Appl. No. 10/605,015
Amdt. dated October 21, 2005
Reply to Office action of August 02, 2005

Amendments to the Drawing:

Fig. 2 Prior art

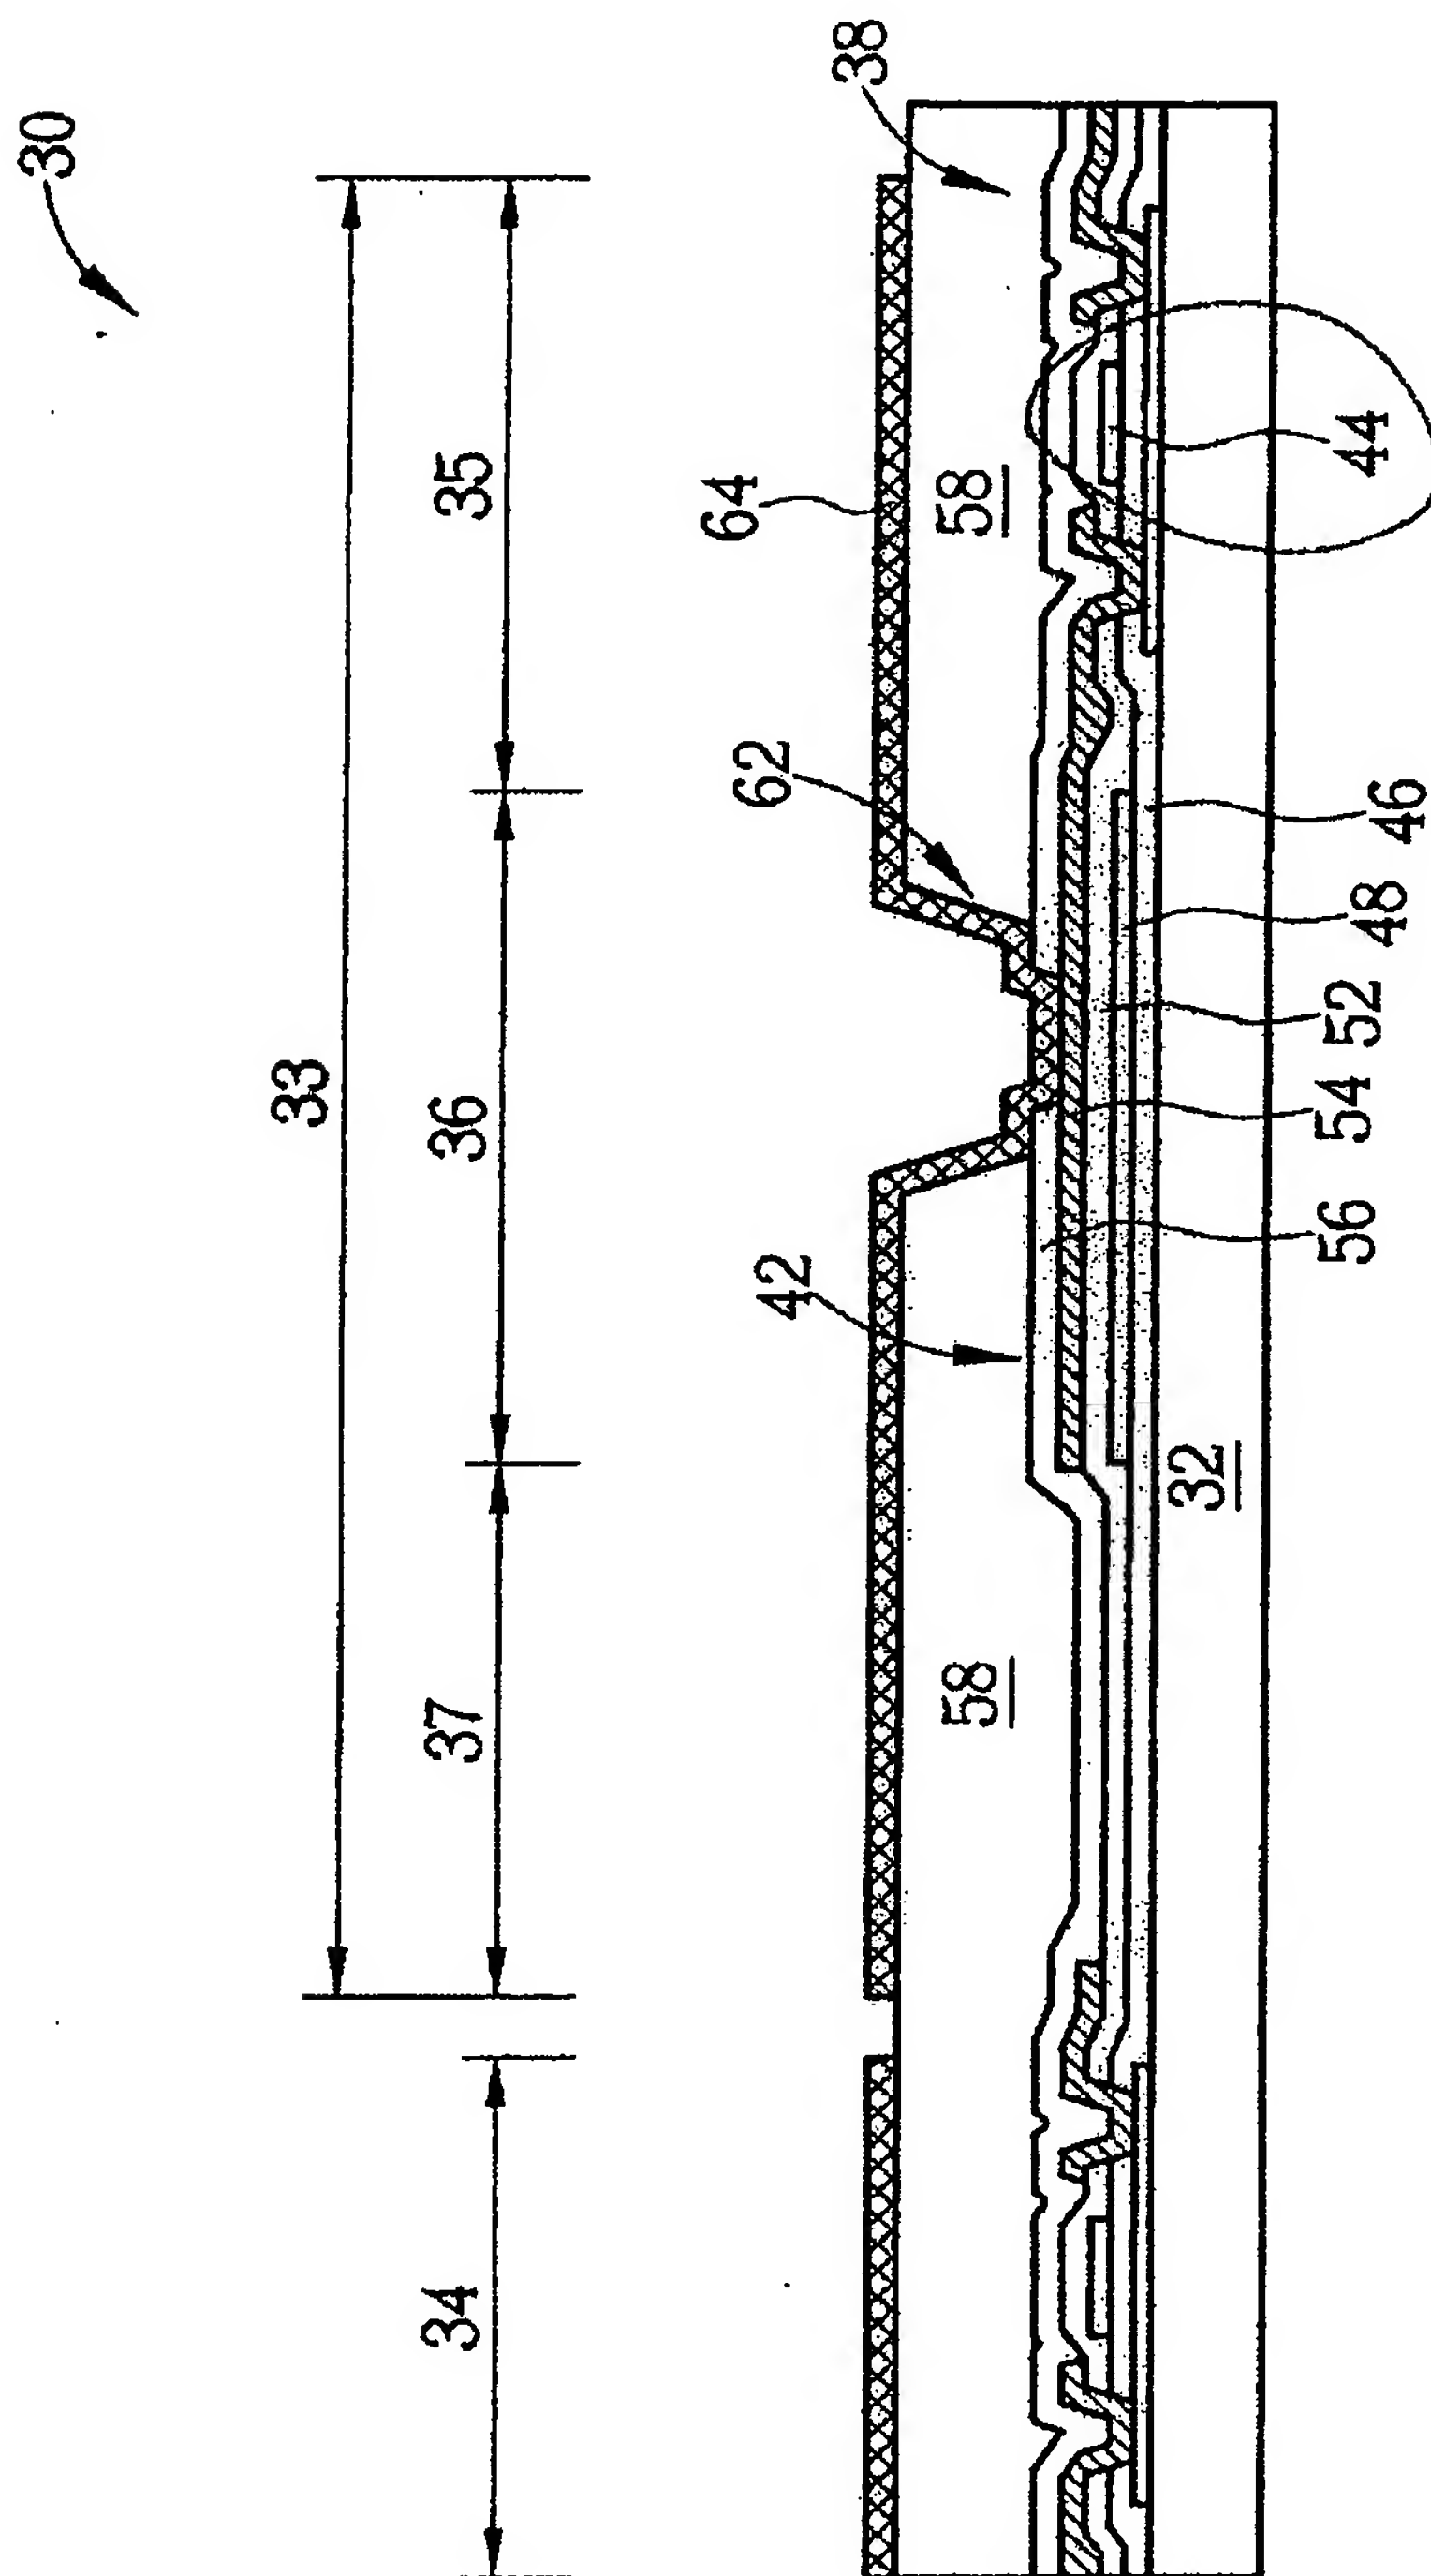
The gate 44 in Fig. 2 and the gate 114 in Fig. 3 are illustrated in wrong positions, and the amendments of drawings correct them.

Fig. 3

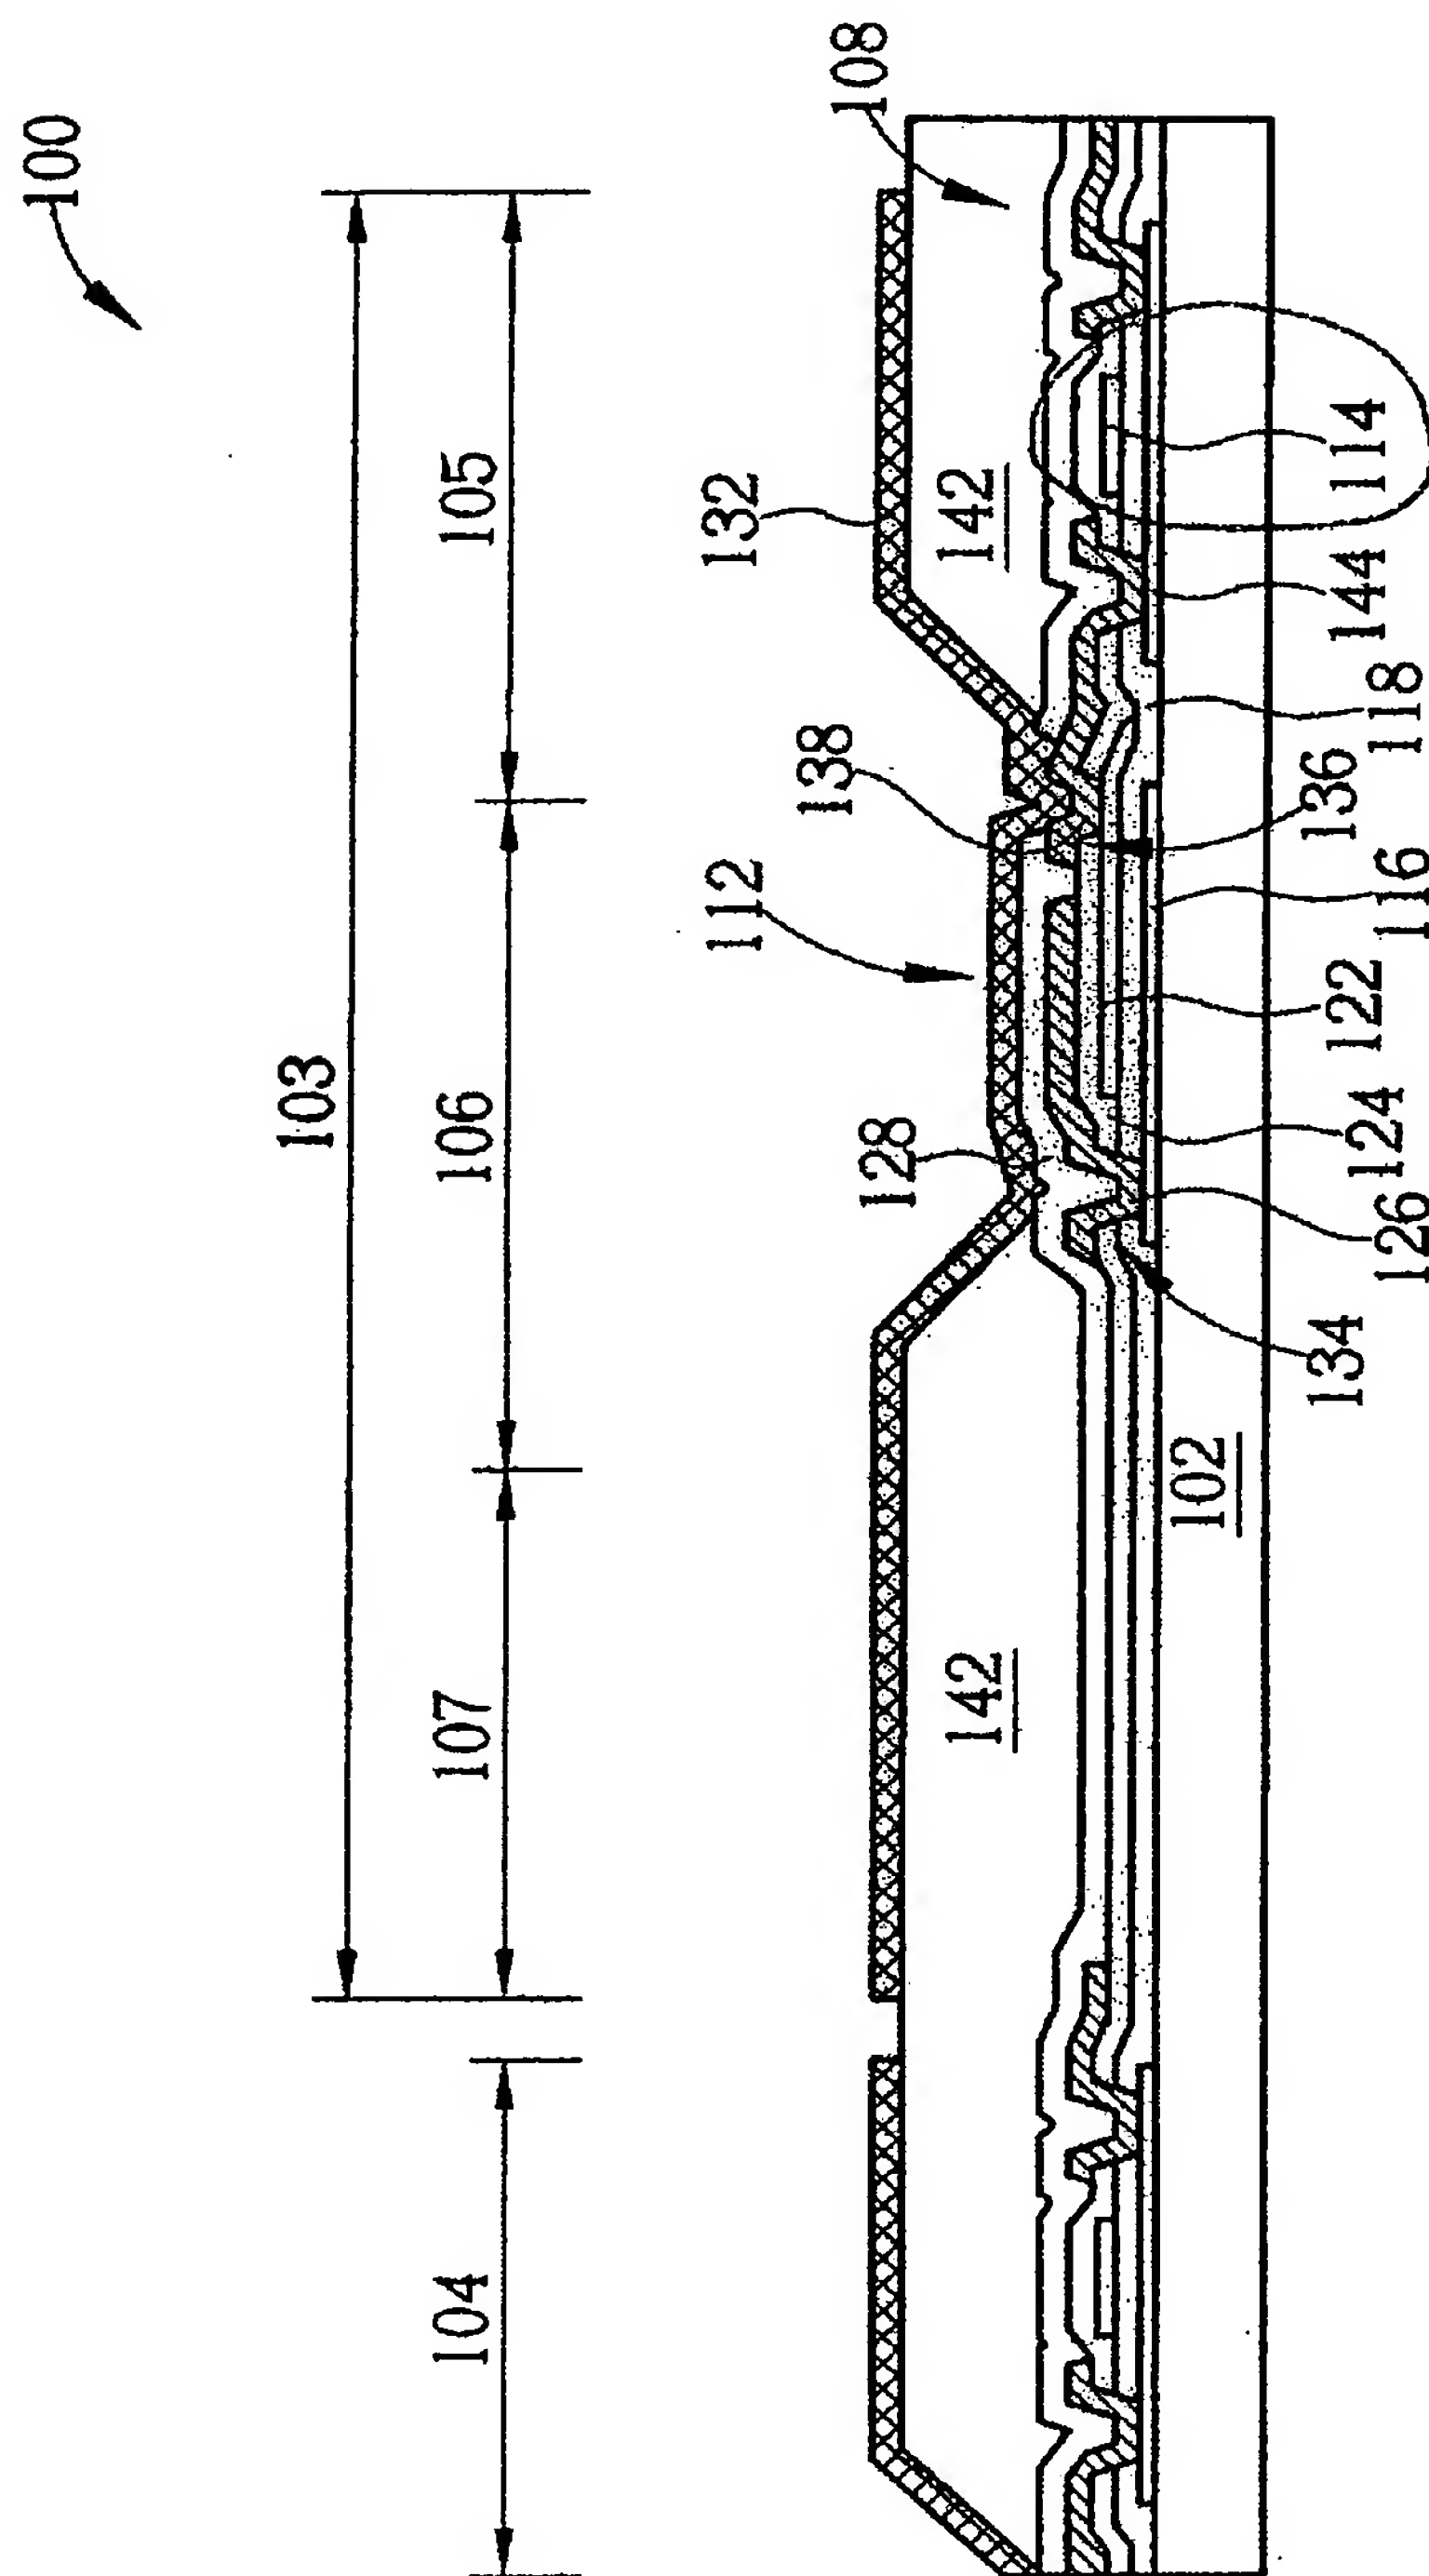
Claim 21 is added to mention: the gate and the capacitor are in the pixel array area. Claim 21 is supported by Fig. 3. Fig. 3 shows the gate 114 and the capacitor 112 are in the pixel array area 103. No new matter is added in claim 21.
